Borrego Springs Watermaster  
Regular Board Meeting  
May 20, 2026 @ 3:00 p.m.

*Technical Review of the UCI GDE Study Report and Recommendations for Next Steps*

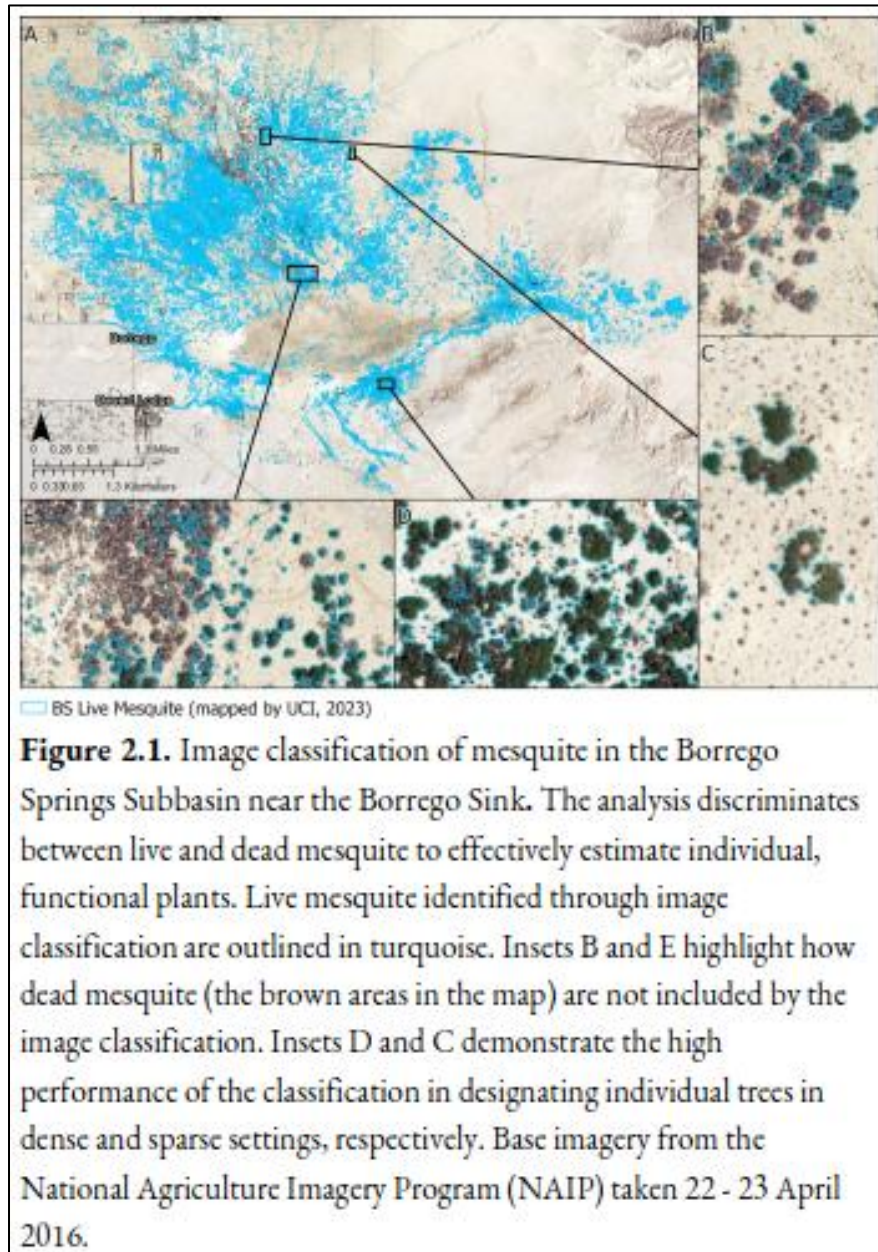
- *BAS determination: Partially Met*
  - The mapping approach of the live Mesquite tree canopy using image classification in ArcGIS Pro appears to produce reasonable results.
  - The resulting maps represent an improved understanding of locations of live Mesquite tree canopy in the BS Mesquite Bosque as of 2016, which establishes a “2016 baseline.”
  - However, the mapping approach should be validated by a remote-sensing specialist.
- Recommendations:
  - The mapping approach in ArcGIS Pro appears to be repeatable and objective, and if so, could be used as a monitoring technique for change detection of the extent and health of the live Mesquite tree canopy over time.
  - Before using this mapping approach for change detection over time, an independent remote-sensing specialist should evaluate and validate the approach and offer any recommended adjustments.

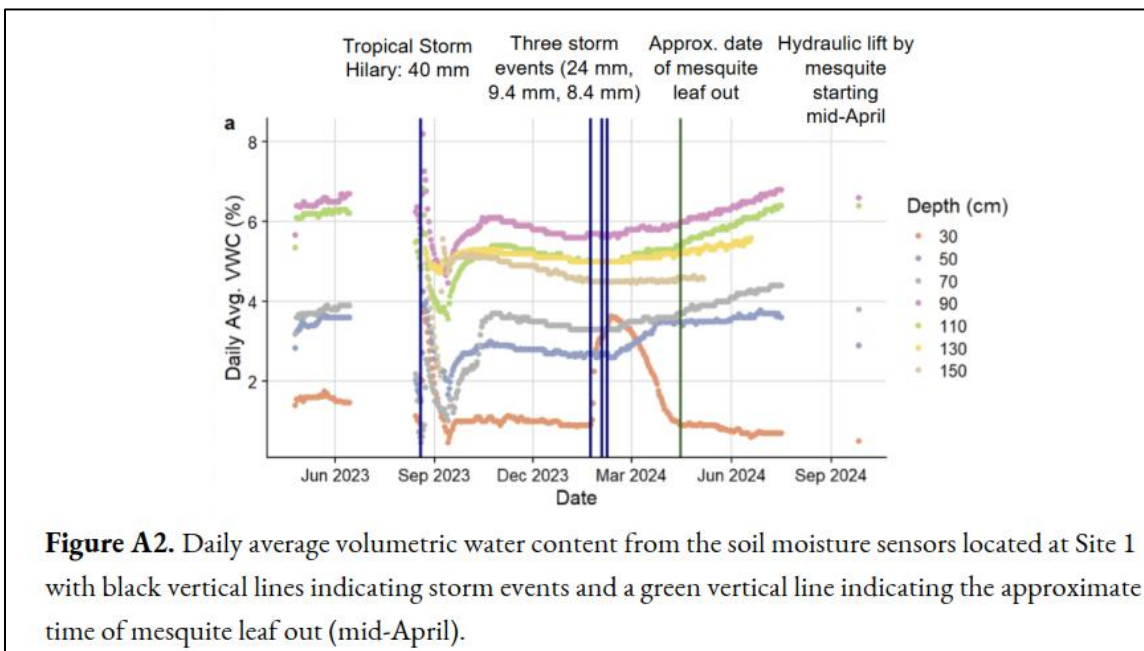
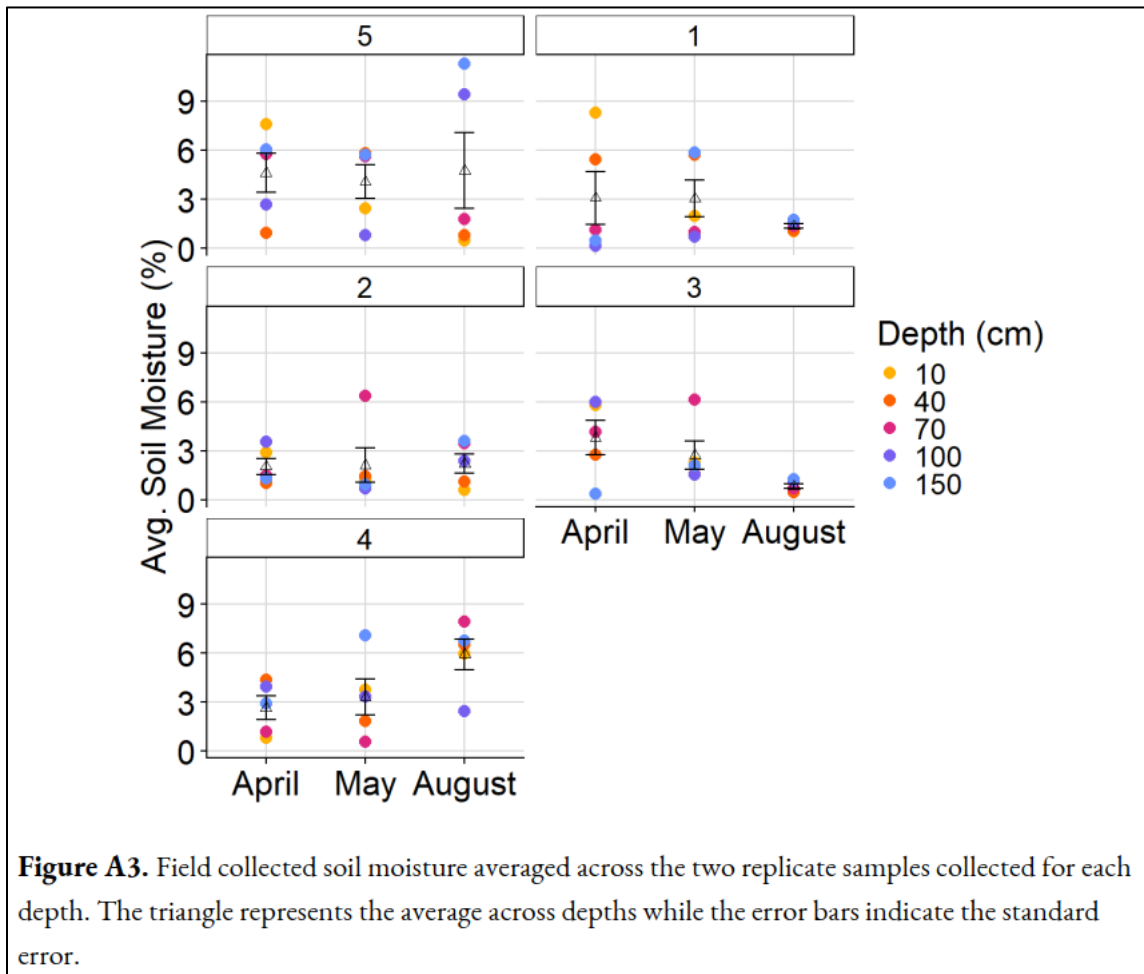
- *BAS determination: Not Met*
  - Soil moisture measured by volume (Figure A.2) is mathematically greater than soil moisture measured by weight (Figure A.3), so the two soil moisture time-series charts in the report (and shown above) cannot be directly compared. Nevertheless, soil moisture less than 10 percent, by weight or by volume, is representative of relatively dry soil conditions, as stated in the report.

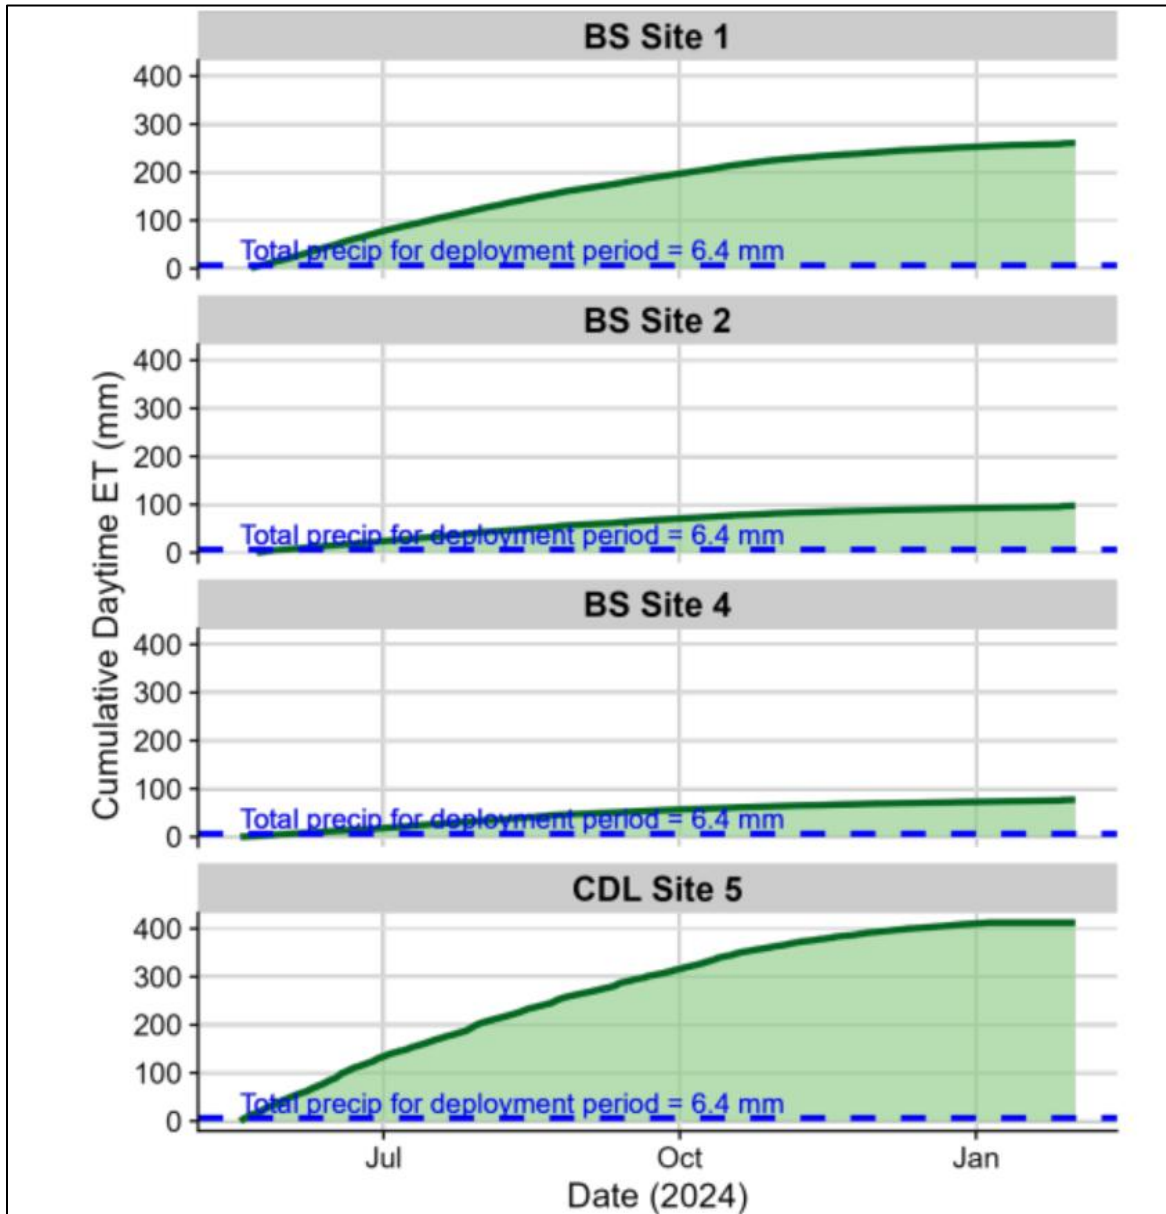
- **BAS determination: Partially Met**
  - We agree that the ET rates measured by the sensors are greater than the rates of direct precipitation; and hence, other source(s) of water must be necessary to satisfy the measured ET rates in the BS Mesquite Bosque over the dry, hot growing season.

- However, we disagree with study conclusion that the ET sensors provide direct evidence of groundwater use by Mesquite trees. The other source(s) of water could be:

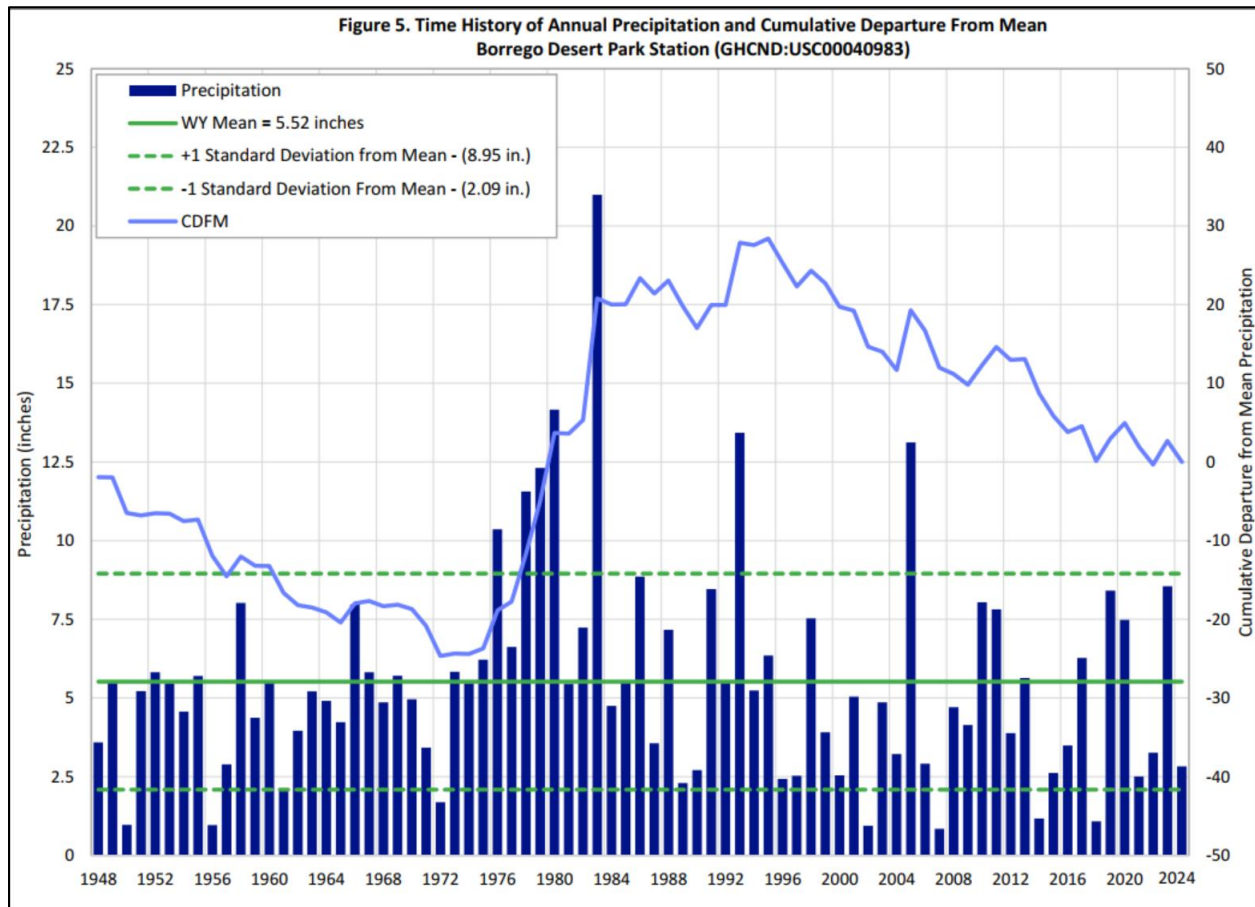
- **BAS determination: Not Met**
  - We disagree that the declining trend in precipitation over the last few decades is not statistically significant. Figure 5 (below) is a plot from the Watermaster's most recent annual report, which illustrates WY precipitation totals, the long-term annual mean precipitation and standard deviation from the mean, and the cumulative departure from mean (CDFM) precipitation for WYs 1948 to 2025. The CDFM plot is a useful way to characterize the occurrence and magnitude of wet and dry periods (relative to the mean): positive sloping segments (trending upward from left to right) indicate wet periods, and negative sloping segments (trending downward from left to right) indicate dry periods. As shown by the CDFM curve on Figure 5, the region has been experiencing a 30-year dry period since 1995, punctuated by a few wet years.

- In our experience of monitoring GDEs in other groundwater basins, annual precipitation can influence NDVI signatures of the vegetated areas.
- *Recommendation:*
  - Climatic data (e.g., precipitation and temperature) should be compared against NDVI data over time to better understand the relationship between climate and the health/extent of the BS Mesquite Bosque.

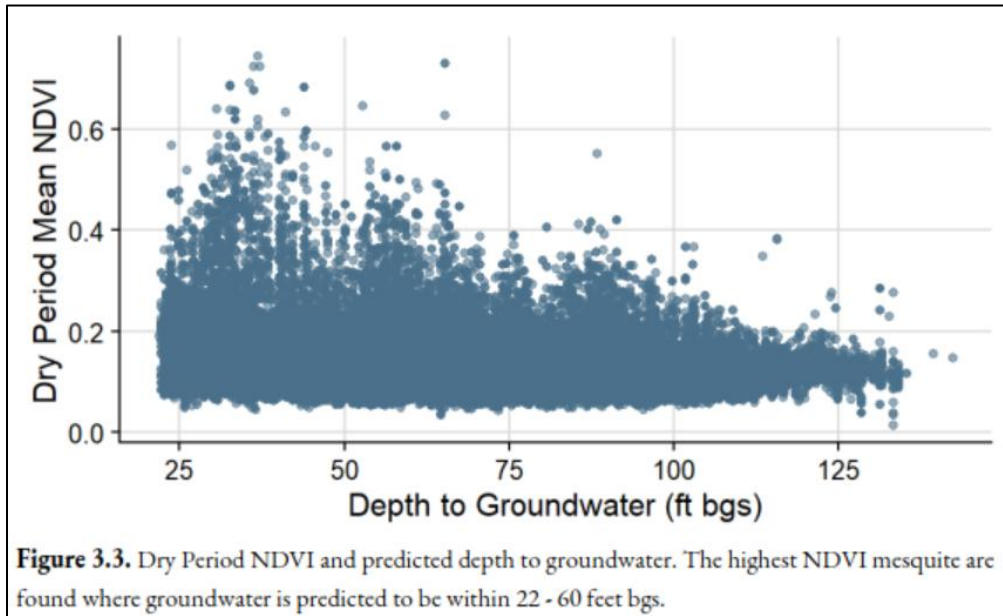
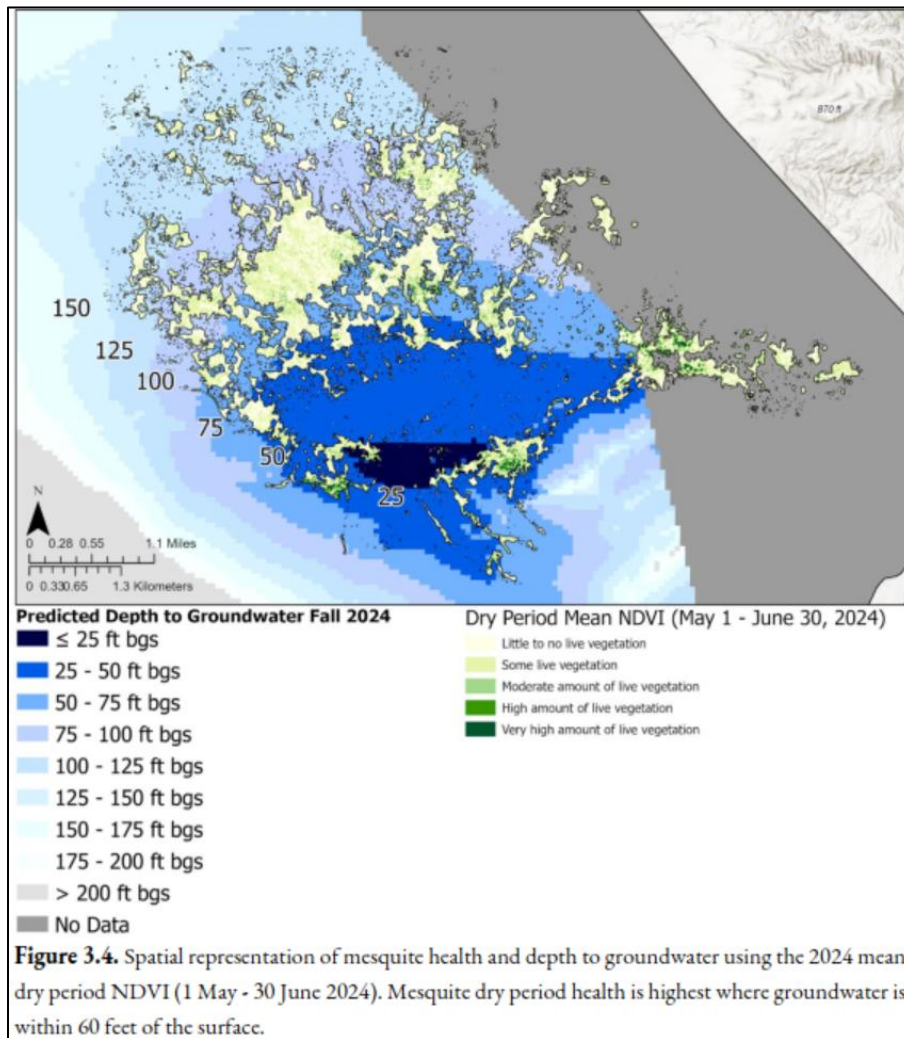
- **BAS determination: Not Met**
  - Figure 3.4 indicates that the more healthy, dense stands of Mesquite trees occur directly surrounding the Borrego Sink. This spatial pattern of healthy Mesquite trees is likely due to greater access to the various water sources in these areas, including:

- Both above.
  - **Data Gaps:** Currently, there are too many data gaps to establish numeric minimum thresholds for groundwater levels, including:
    - *A paucity of measured depth to the groundwater table and its capillary fringe.* As noted earlier in this memorandum, depth to the regional groundwater table is not accurately known in some areas of Figure 3.4. This is particularly true in the areas of the healthiest stands of Mesquite trees surrounding the Borrego Sink due to a lack of monitoring wells. In addition, the thickness of the capillary fringe above the
